**Amendment No. 2 to Clean Water Act Section 401
Water Quality Certification No. 11C-026**

**PROJECT: BAE Systems San Diego Ship Repair Pier 4
Replacement Project
Certification Number 11C-026
WDID: 9000002252**

Amendment No. 1 to Clean Water Act Section
401 Water Quality Certification
and Waste Discharge Requirements
for Discharge of Dredged and/or Fill Materials

**PROJECT: BAE Systems San Diego Ship Repair Pier 4
Replacement Project Certification Number (11C-026)**

Figure titled "Pier 4 Mooring Fender System", BAE Drawing G-1 and G-2 is added to Attachment 5.

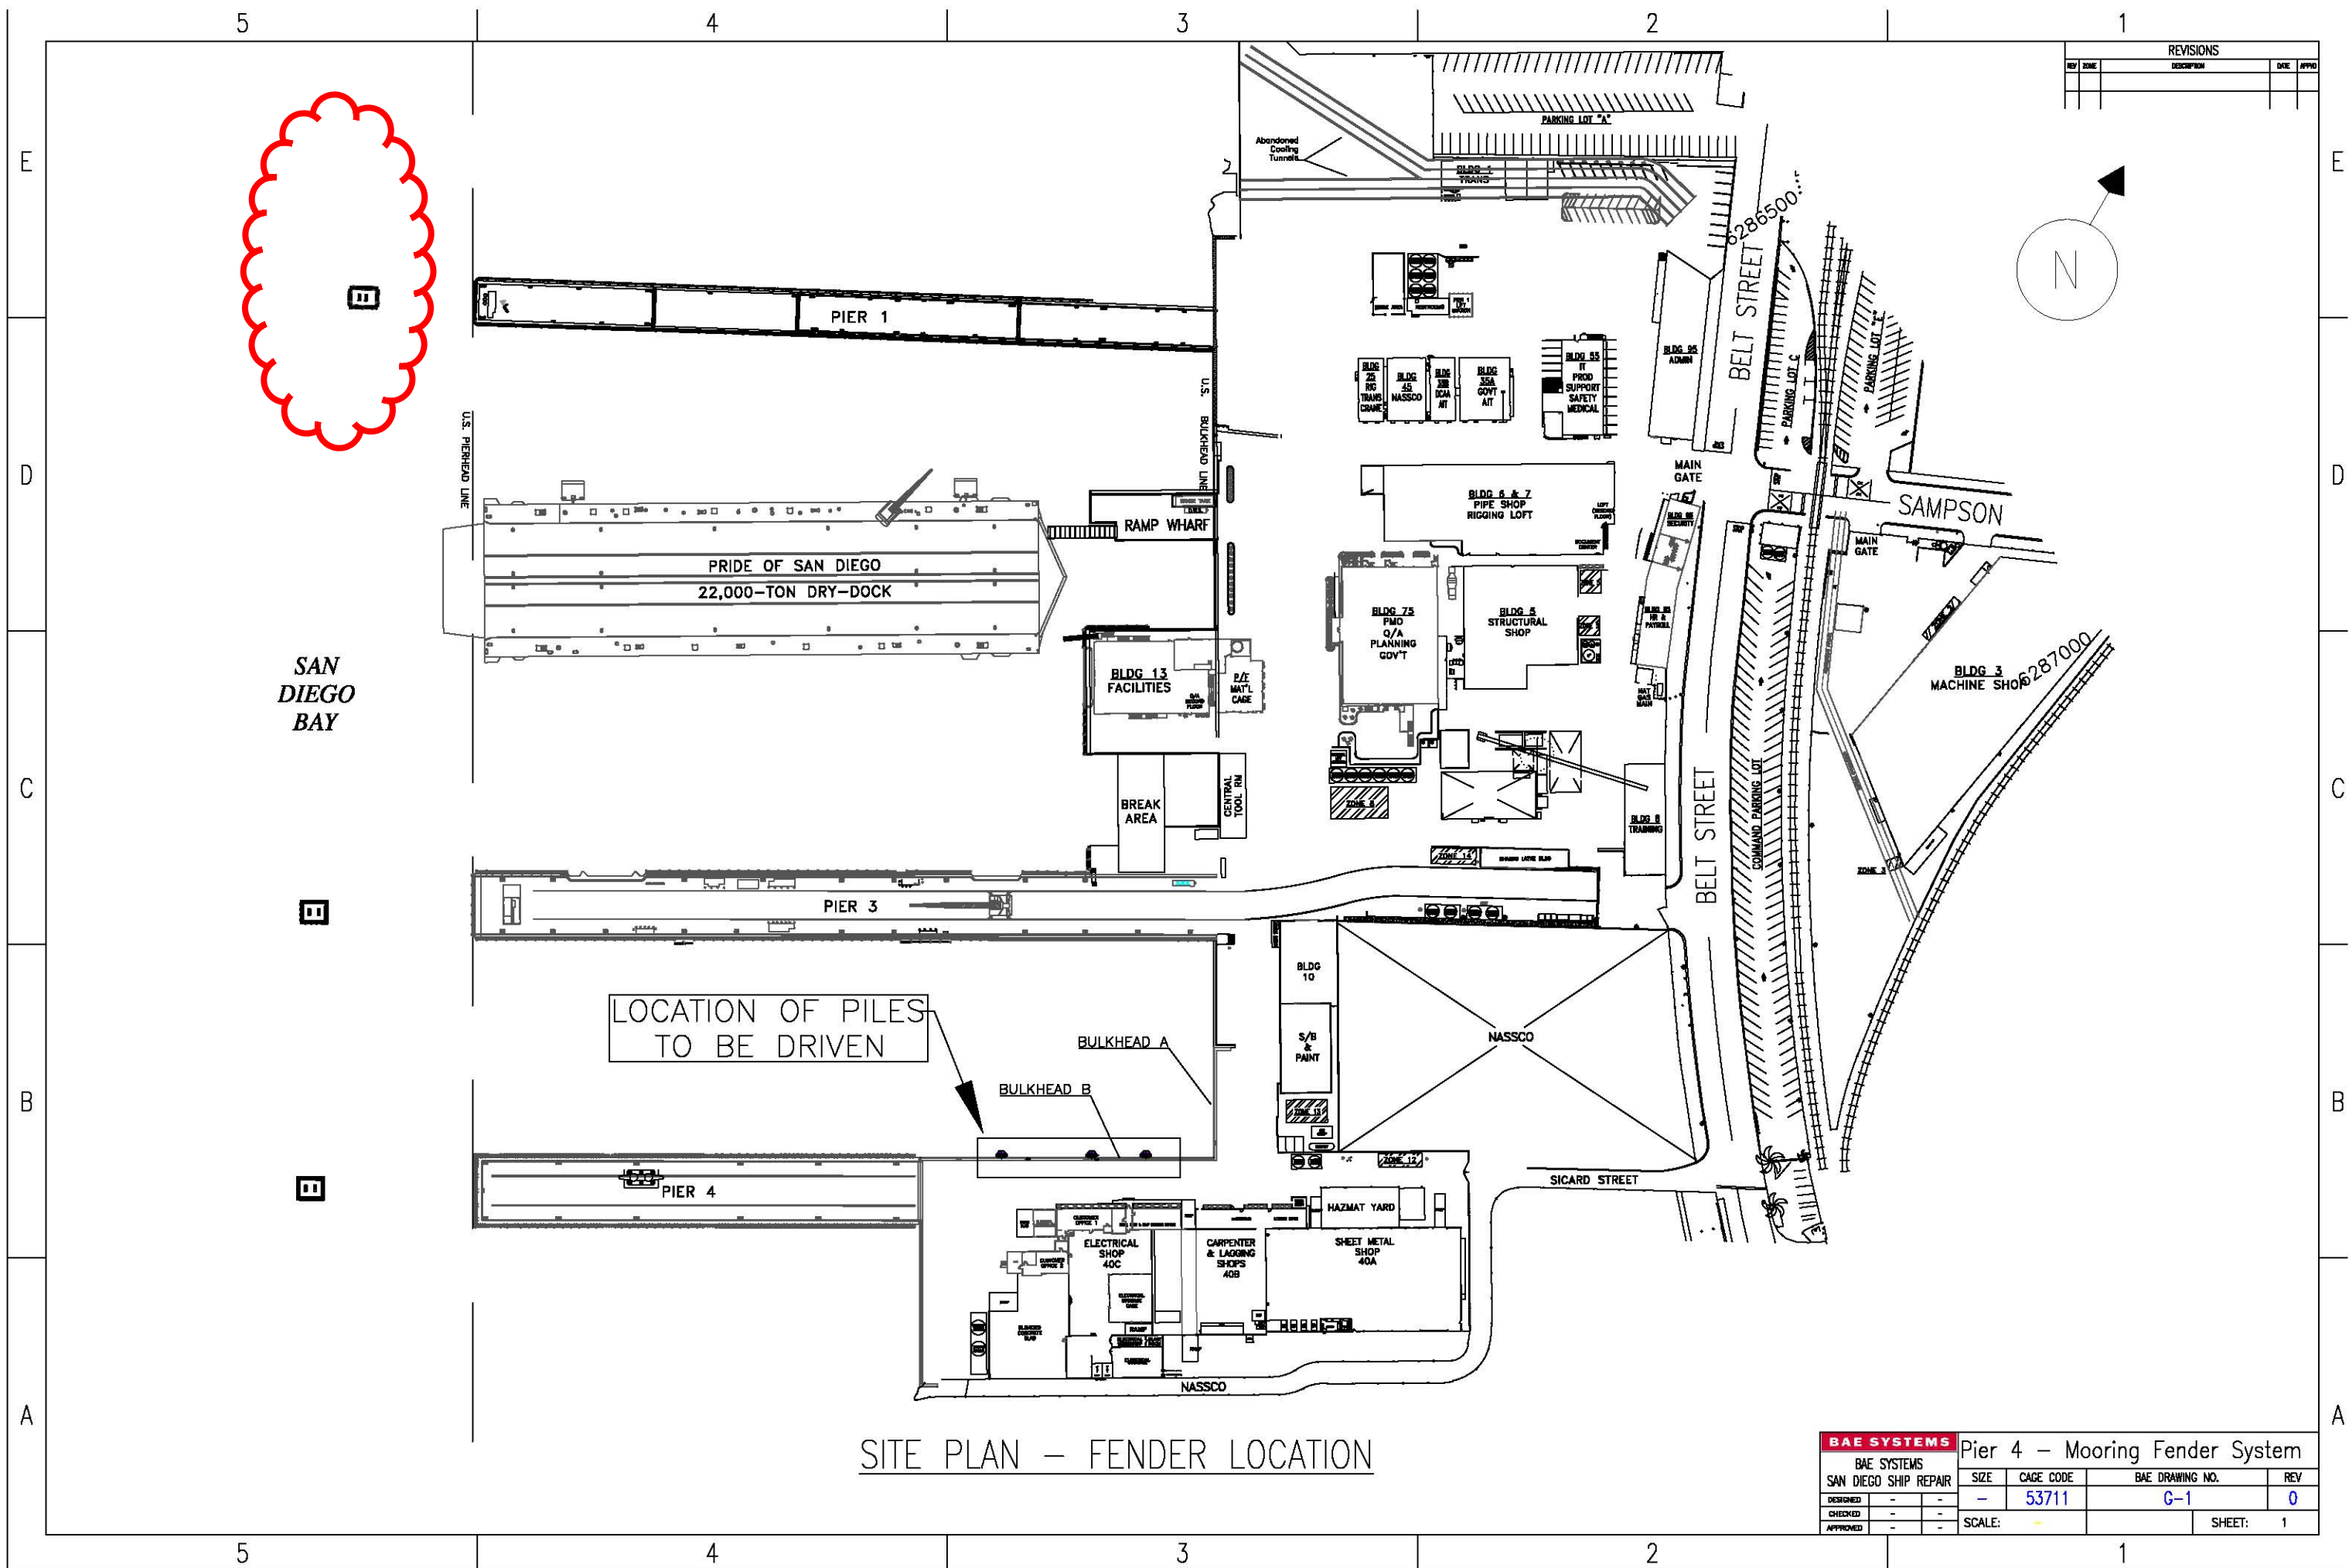
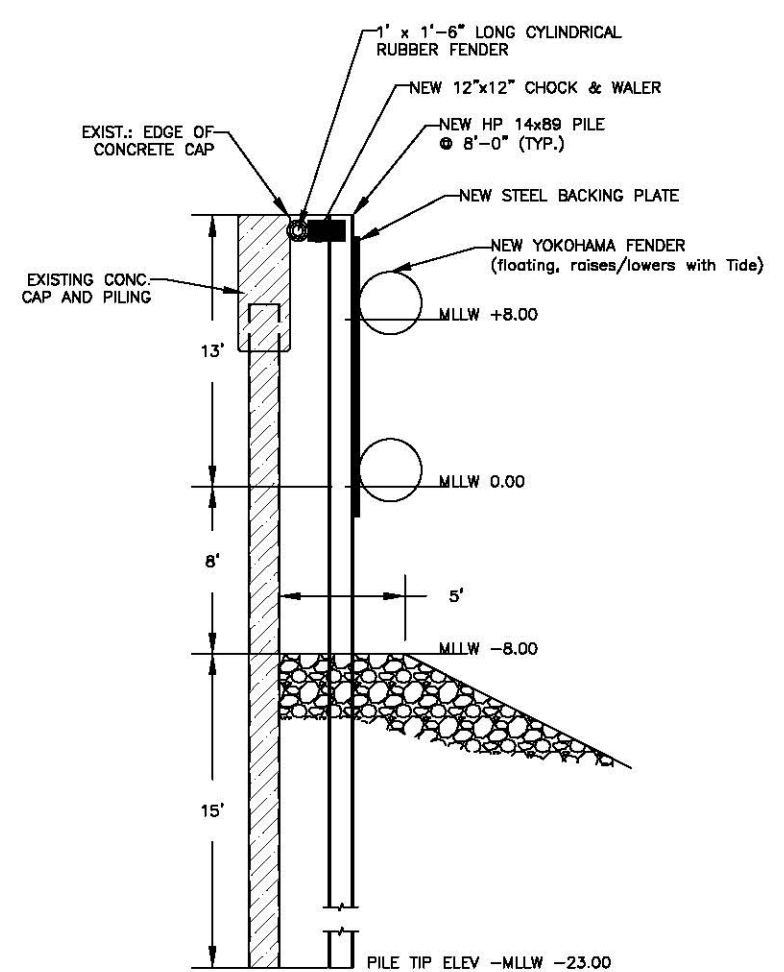
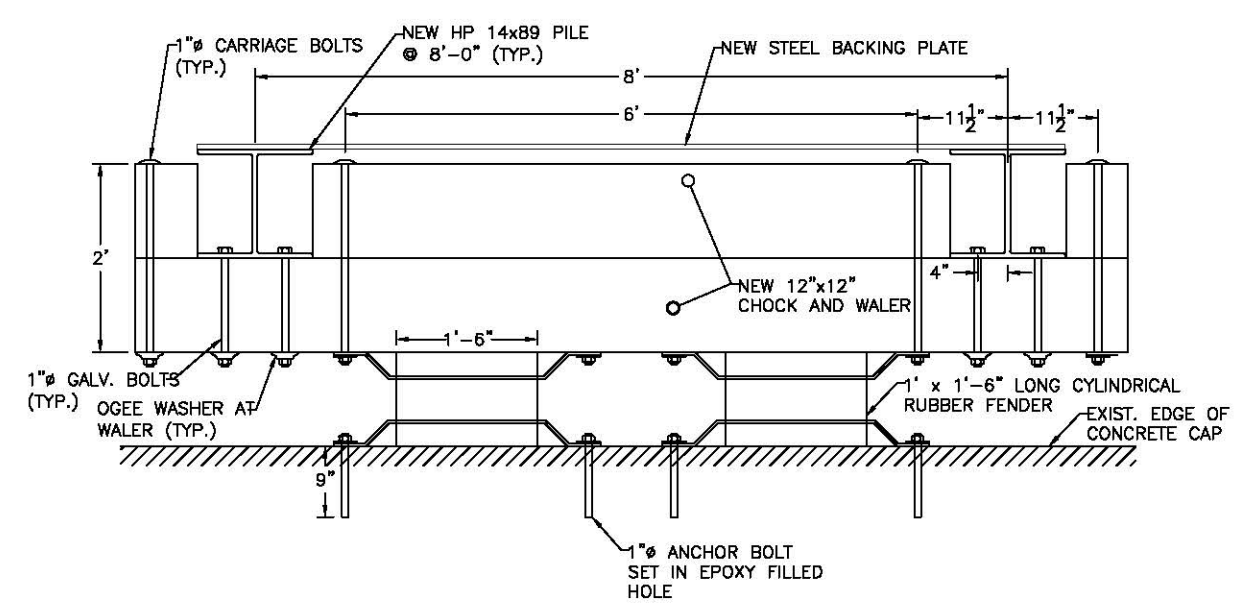
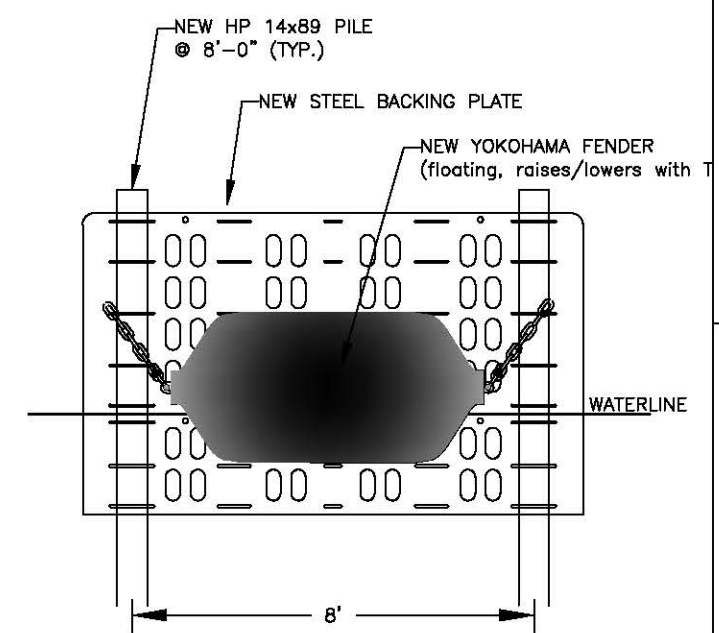
By letter dated March 18, 2015, the Applicant requested the Certification be amended a second time to include the construction of a mooring fender system for Pier 4. The mooring fender system was accidentally omitted from the Pier 4 plans and consequently the work was not included in the Certification. Excluding gaps and fender tapers, the mooring fender system would add less than 150 square feet of bay coverage to the pier. The Unified Port District of San Diego has approved the Applicant's use of additional shading credit mitigation for the additional coverage to San Diego Bay that will result from the installation of the mooring fender system.

10. Page 36, Attachment 5, Conceptual Design, is modified as follows:
